MFN 08-145

**Subject: Response to NRC Request for Additional Information Letter 131
Related to the ESBWR Design Certification – Radioactive Waste
Management Systems – RAI Numbers 11.2-16S01, 11.2-17
through 11.2-31, 11.3-4 through 11.3-12, 11.4-15S02, 11.4-19
through 11.4-32, and 11.5-48 through 11.5-53**

**Response to Portion of NRC Request for
Additional Information Letter No. 131**

Radioactive Waste Management Systems

Figure 11.4-2. SWMS Spent Resin Sludge Transfer System Wet Solid Waste Collection Subsystem

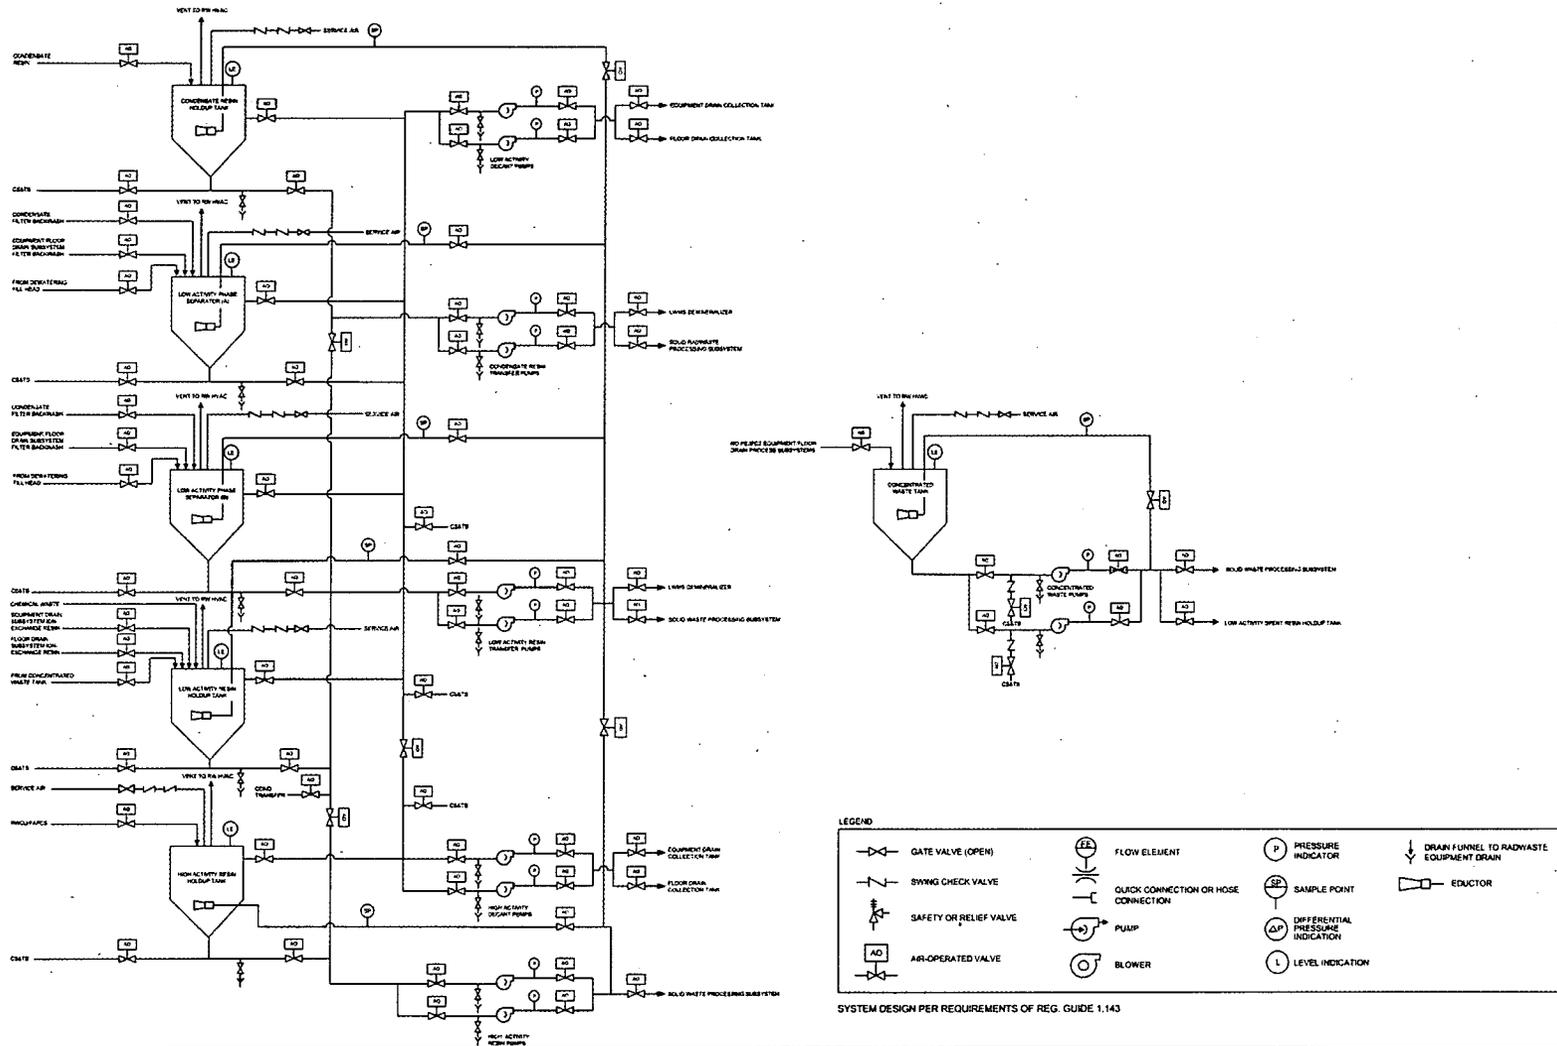
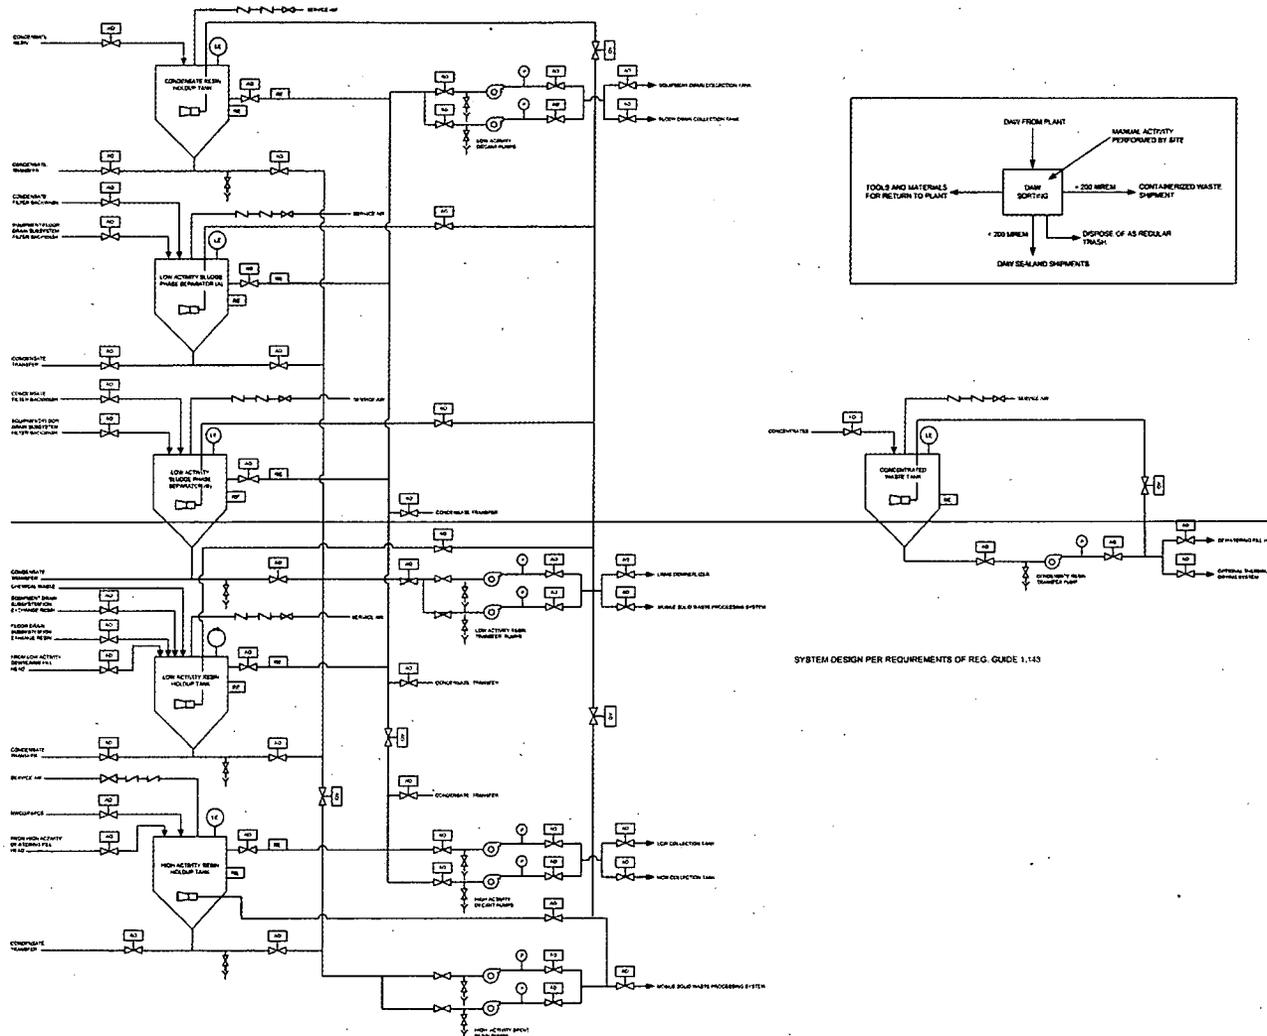
DCD, Tier 2, Figure 11.4-2 includes Sample Point in the legend box, but none are noted in the system drawing. Provide the technical rationale for not including sampling points. Note that waste products processed by this subsystem will need to be characterized in determining compliance with the waste form characteristics of 10 CFR Part 61.55 and 61.56 and waste acceptance criteria of the radwaste disposal site. If sampling points are not included by design in this subsystem, describe alternate means for sampling waste streams and products from this subsystem in DCD, Tier 2, Sections 11.4.2.2 and 11.4.6 (COL information Item 11.4-3-A, Process Control Program).

DCD, Tier 2, and Figure 11.4-2 shows the Concentrated Waste Tank being pumped to the Solid Waste Processing Subsystem, yet Figure 11.4-3 does not show this input. Figure 11.4-1 shows an input to the Low Activity Resin Holdup Tank from Concentrated Waste, yet Figure 11.4-2 does not show this input. Address these discrepancies in system flow paths and revised tank. DCD, Tier 2, Section 11.4.2 and associated figures accordingly.

In DCD, Tier 2, Figure 11.4-2, the horizontal line coming from the bottom of Phase Separator (A) ends abruptly with no connections to other portions of the system. The vertical line coming from the bottom of the Condensate Resin Holdup Tank, after the second air-operated valve, ends abruptly as well. Address these inconsistencies in system flow paths and revise DCD, Tier 2, Figure 11.4-2 accordingly.

DCD, Tier 2, Figure 11.4-2 identifies the presence of 11 radiation monitors (see symbol RE in figure), but DCD, Tier 2, Sections 11.4.5, 11.5.3, and 12.3 (Table 12.3-4) do not describe such radiation monitors. The radiation monitors are shown to be mounted on tanks/vessels and subsystem piping. The description and operational functions of the radiation monitors are not described in the proposed revision of DCD, Tier 2, Section 11.4. Confirm whether such radiation monitors are part of the design; if so, provide information about their operational functions; and revise DCD, Tier 2, Sections 11.4.5, 11.5.3, and 12.3, and associated tables and figures.

GEH concurs with the staff and will revise DCD, Tier 2, Figure 11.4-2 to include Sample Points for waste products processed by this subsystem to enable characterizing waste for compliance to 10 CFR Part 61.55 and 61.56, and waste acceptance criteria of the radwaste disposal site.

GEH concurs with the discrepancy identified by the staff. DCD, Tier 2, Figure 11.4-2 will show the Concentrated Waste Tank being pumped to the Solid Waste Processing Subsystem (Figure 11.4-3 now shows this input). Figure 11.4-2 now shows an input from the concentrated waste tank.

GEH agrees that the drawing inconsistency exists and will correct the drawing inconsistencies in system flow paths and revise DCD, Tier 2, Figure 11.4-2 accordingly.

GEH agrees the radiation monitors shown on DCD, Tier 2, Figure 11.4-2 are not described or identified in DCD, Tier 2, Sections 11.4.5, 11.5.3, and 12.3, and associated tables and figures. DCD, Tier 2, Figure 11.4-2 will be revised to delete these radiation monitors as they are no longer part of the design. These monitors were previously added for operational convenience and are not required to perform a safety or operational function described in Chapter 11.

Figure 11.4-3. ~~SWMS Solid Radwaste Dewatering System (Conceptual Design)~~ Wet Solid Waste Processing Subsystem

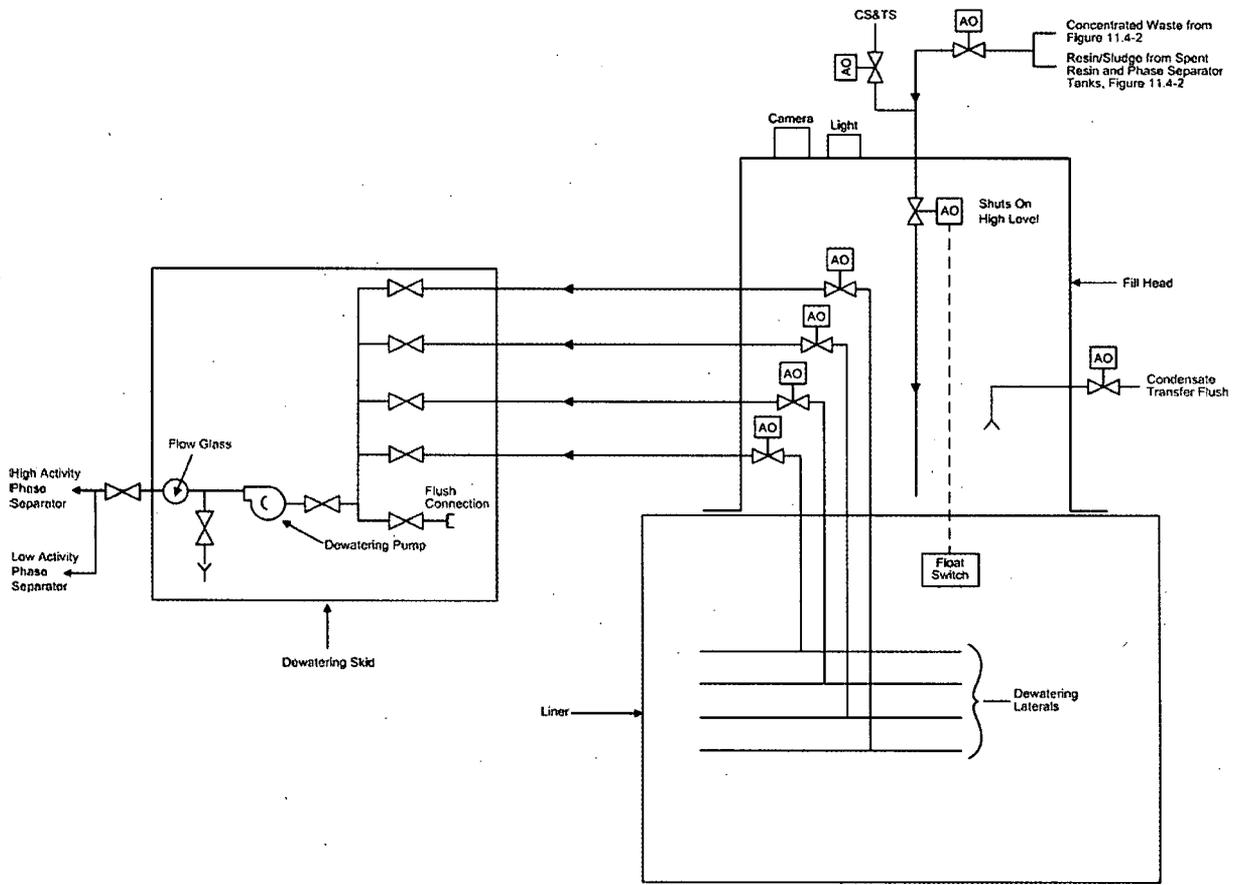
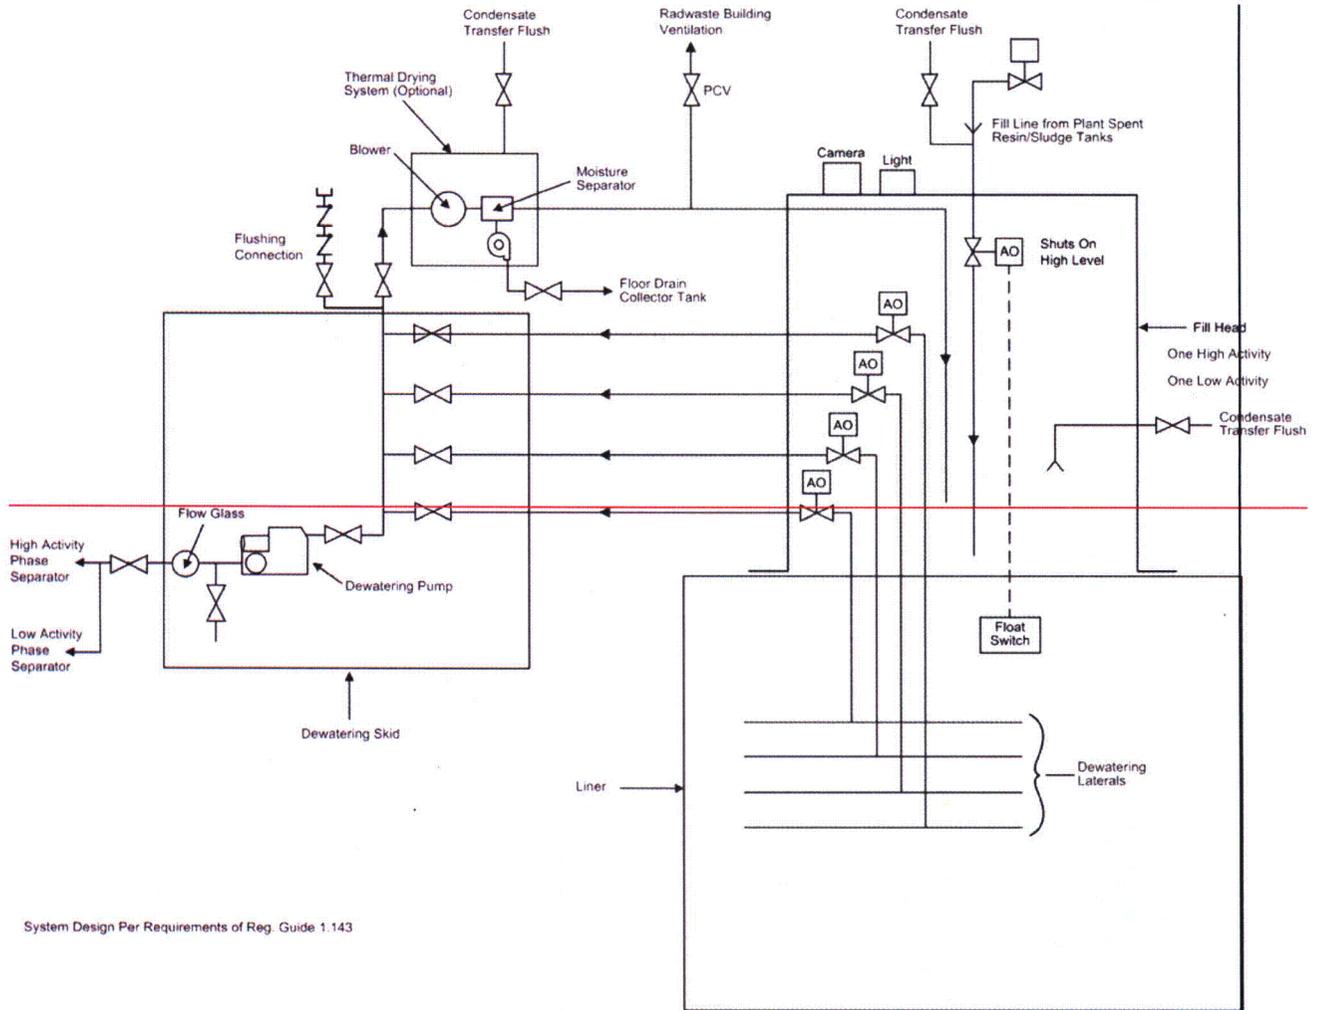
The "Thermal Drying Unit" as described in DCD, Tier 2, Section 11.4.2.2 "wet solid waste processing subsystem" and shown on Figure 11.4-3, is listed as an option. Clarify if this equipment is within the scope of the DCD, Tier 2 and revise DCD, Tier 2, Section 11.4.2.2 accordingly.

DCD, Tier 2, Figure 11.4-3 describes the function of the "dewatering pump. This pump appears to be drawn backwards in the figure. As drawn, it appears to be pumping from the High and Low Activity Phase Separators into the Liner and Thermal Drying Units. Also, on the dewatering skid drawing, there is an open gate valve with no disposition or connection to other portions of the subsystem. Confirm the flow direction of the dewatering pump, address the inconsistencies in system flow paths, and revise DCD, Tier 2, Section 11.4.2 and Figure 11.4-3 accordingly.

GEH concurs the need to clarify DCD, Tier 2, Subsection 11.4.2.2 "wet solid waste processing subsystem" and Figure 11.4-3, and will remove the "Thermal Drying Unit".

GEH agrees with the inconsistencies in flow direction of the dewatering pump, system flow paths, and will revise DCD, Tier 2, Figure 11.4-3 accordingly.

Figure 11.4-4. Dry Active Waste Processing

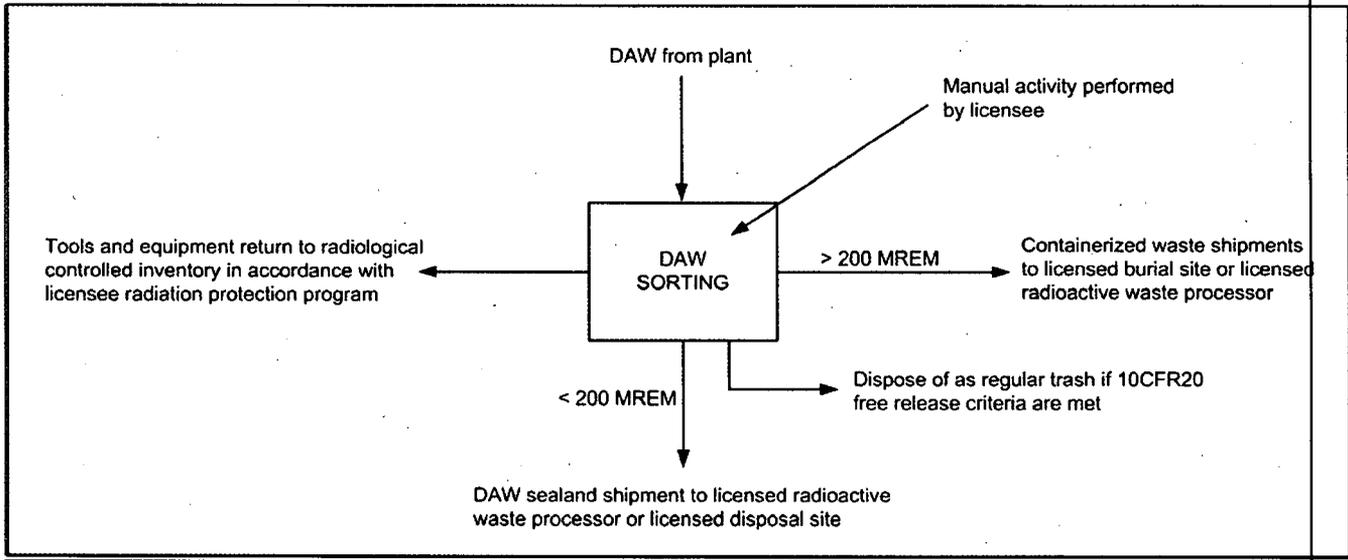
DCD, Tier 2, Figure 11.4-4 shows the disposition of dry solid wastes, but it does not address NRC requirements and policy for their disposition.

- a. For wastes processed manually, the figure should note that such activities are performed by the COL holder.*
- b. For tools and materials returned to plant, the figure should note that they would be returned for controlled use and uncontrolled use consistent with the COL holder's radiation protection program.*
- c. For disposal as regular trash, the figure should note that such dispositions would comply with the NRC policy on non-detectable activity for the release of materials and equipment from nuclear power plants.*
- d. For radioactive waste destined for DAW Sealand shipments, the figure should note that the endpoints of such shipments are authorized low-level radioactive waste disposal sites and licensed waste processors.*

As shown, the figure conveys disposition methods of radioactive materials contrary to Part 20.2001 and NRC policy for the release of materials and equipment from nuclear power plants in unrestricted areas. Accordingly, revise DCD, Tier 2, Figure 11.4.4 by changing the legend or introducing appropriate footnotes to each shown disposition endpoints.

GEH agrees with the staff's identification of inadequacy of the dry active waste (DAW) processing description in DCD, Tier 2, Figure 11.4.4, and will revise the figure to describe disposition methods of radioactive materials that are not contrary to Part 20.2001 and NRC policy for the release of materials and equipment from nuclear power plants in unrestricted areas.
